SOUTH CENTRAL WATERFRONT COMBINING DISTRICT & DENSITY BONUS PROGRAM (DRAFT – Staff Recommendations)

PLANNING DEPARTMENT
CITY OF AUSTIN

Figure 3.2: SCW Subdistrict and Floor-to-Area Ratio Map

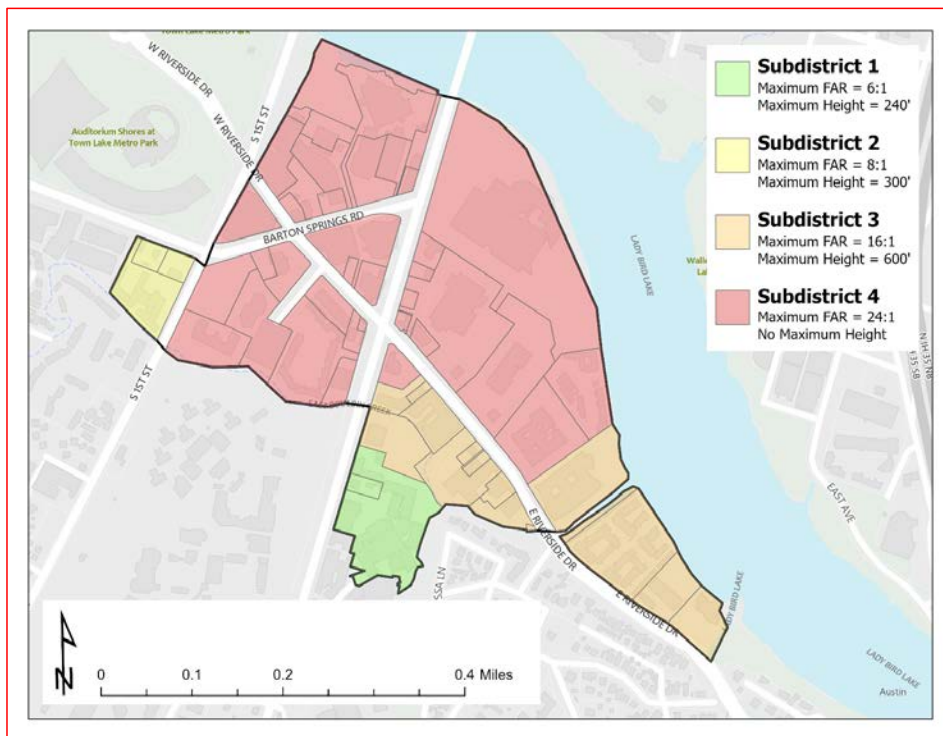
Commented [MS1]: Planning Commission Recommendation: Remove Subdistrict 1 and renumber:

Subdistrict 1:

~~The lowest density subdistrict, Subdistrict 1 serves as a transitional buffer between existing low density residential to the east and the subsequent low medium density of Subdistrict~~

~~The boundaries of Subdistrict 1 shall apply to the portions of property no less than 250 feet from the public right of way along South Congress Avenue.~~

- ~~a. The maximum floor to area ratio is 3:1.~~
- ~~b. The maximum building height is 120 feet.~~

Staff recommends this amendment.

Figure 4.2: Internal Circulation Route Option 2 Cross Section

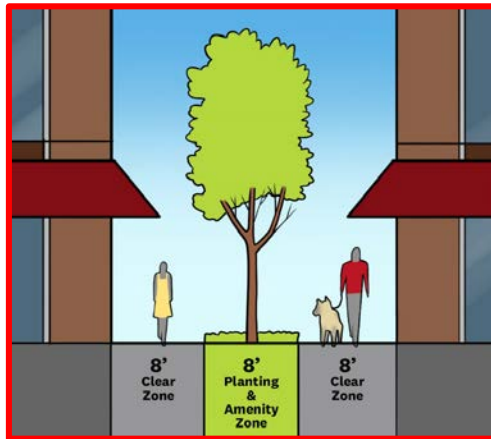
Commented [MS5]: Planning Commission Recommendation: Increase from 10-foot to 15-foot.

Commented [MS6]: Planning Commission Recommendation: Expand the clear zone from 5 to 7.5 feet on each side. This recommendation was increased to 8 feet to comply with the Americans with Disabilities Act.

Figure 4.3: Internal Circulation Route Option 3 Cross Section

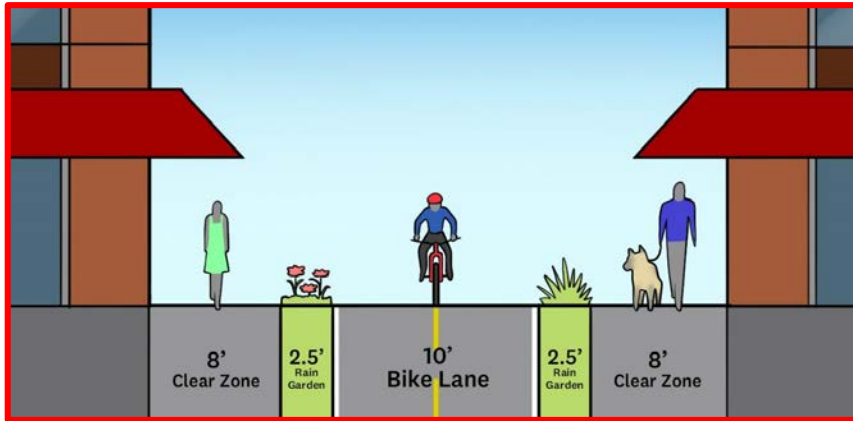
Commented [MS8]: Planning Commission Recommendation: Expand the clear zone from 5 to 7.5 feet on each side. This recommendation was increased to 8 feet to comply with the Americans with Disabilities Act.

Commented [MS9]: Staff recommends change to rain garden(s) from planting zone(s).

Figure 4.4: Internal Circulation Route Option 4 Cross Section

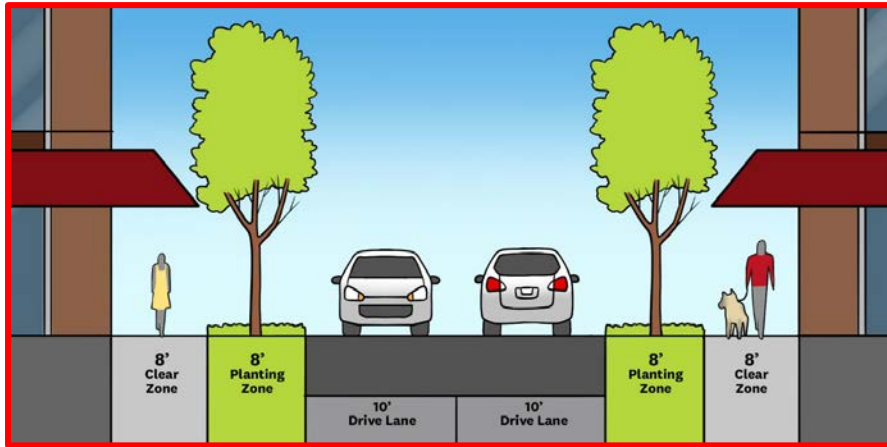
Commented [MS10]: Staff recommendation for shade trees.
